Intel[®] Pentium[®] III Xeon[™] Processor Specification Update

Release Date: May 2001

Order Number: 244460-028

The Pentium[®] III Xeon[™] processor may contain design defects or errors known as errata that may cause the product to deviate from published specifications. Current characterized errata are documented in this Specification Update.

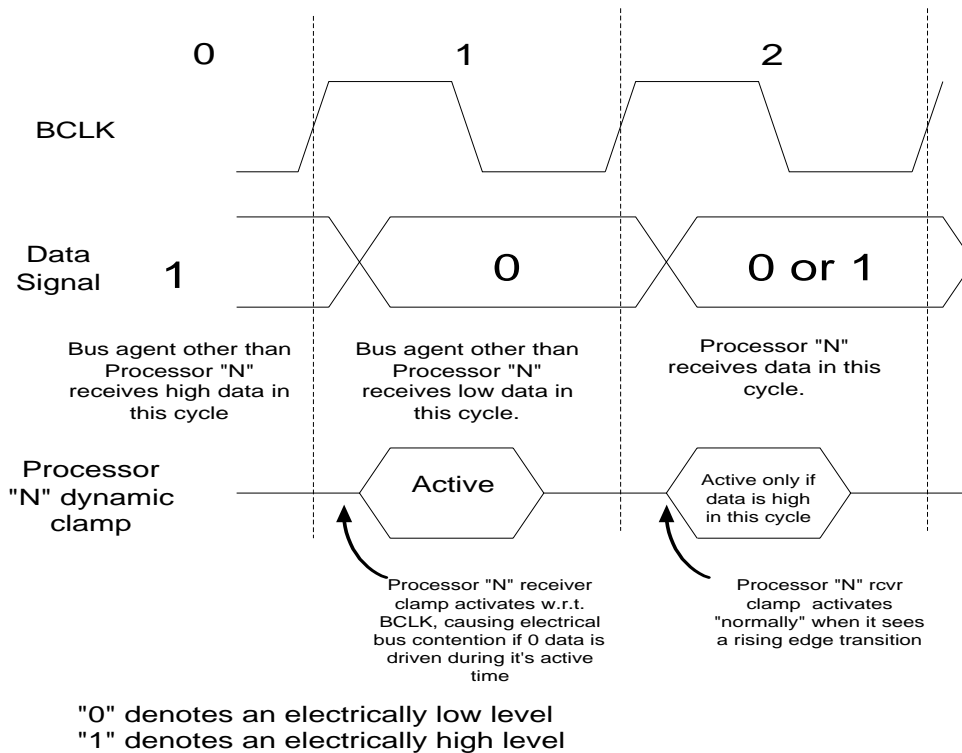
Workaround: The AGTL+ V_{REF} (input voltage reference) level will be raised from 1.0V to 1.1V (assuming a V_{TT} of 1.5V) on the processor cartridge substrate. This allows the dynamic clamp to activate at a trigger level approximately 100 mV higher than with the previous 1.0V V_{REF} setting. Due to the dependence upon system bus design, bus layout may be evaluated to determine the need for improvements in falling edge ringback levels. This may involve one or several of the following baseboard modifications:

1. Change termination resistor value to reduce multi-bit noise and/or improve V_{IL} noise margin.
2. Reduce multi-bit noise by improving ground return paths (additional high-frequency decoupling, improved AC plane referencing, etc.).
3. Raising or lowering the V_{TT} level (within the AC & DC tolerances specified in the processor EMTS) to improve V_{IL} noise margin and/or reduce the multi-bit noise due to dl/dt transients.
